To: Chow, Alice [chow.alice@epa.gov]
Subject: RE: [External] Maps of EtO sterilizers

Subject: [External] Maps of EtO sterilizers

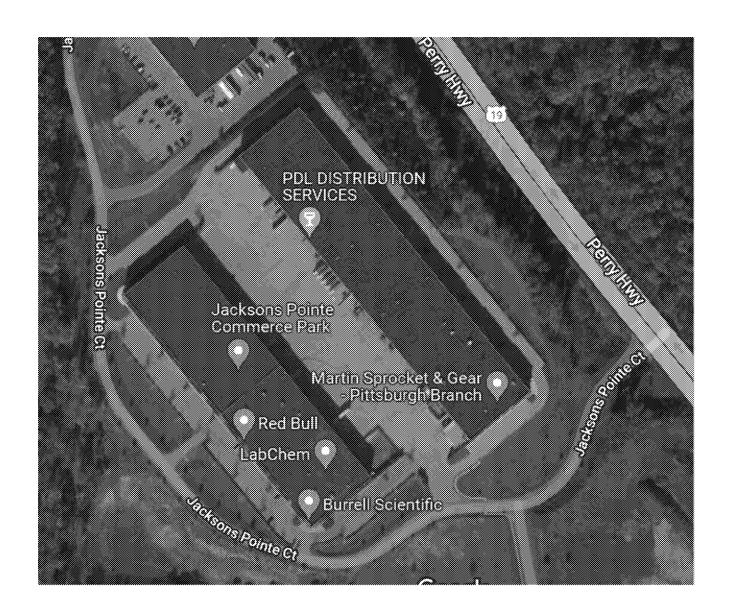
Matt: Google maps have the address of 2010 Jackson Pointe Ct., it's where the orange colored building is on the isopleth map.

4040 Jackson Pointe Ct where ACS is on the other side...in between 2 other facilities...PDL Distribution is at 5000 Jackson Pointe Ct, Martin Sprocket & Gear is at 3010 Jackson Pointe Ct.

Thanks for the update. The info we had based on the address of the facility was the building we had marked on the isopleth map. I assume the info from PA is more accurate. Is there anyway you can confirm PA's location?

The map provided by EPA for ACS Zelienople is incorrect. The building highlighted in the map is not the correct location for the facility. ACS Zelienople is located in the adjacent building, as highlighted by my comment in the attachment.

Thanks Alice, that was really helpful. We had modeled it at the 2010 Jackson Point Ct. (incorrect) address. I just moved it to the correct location and remodeled. It did bring the risk down slightly to 147-in-1 million (down from 168-in-1 million), which after rounding will be presented as 100-in-1 million. We'll work on getting an updated gradient map with the corrected location and risks. Here is the location I just used to model it:
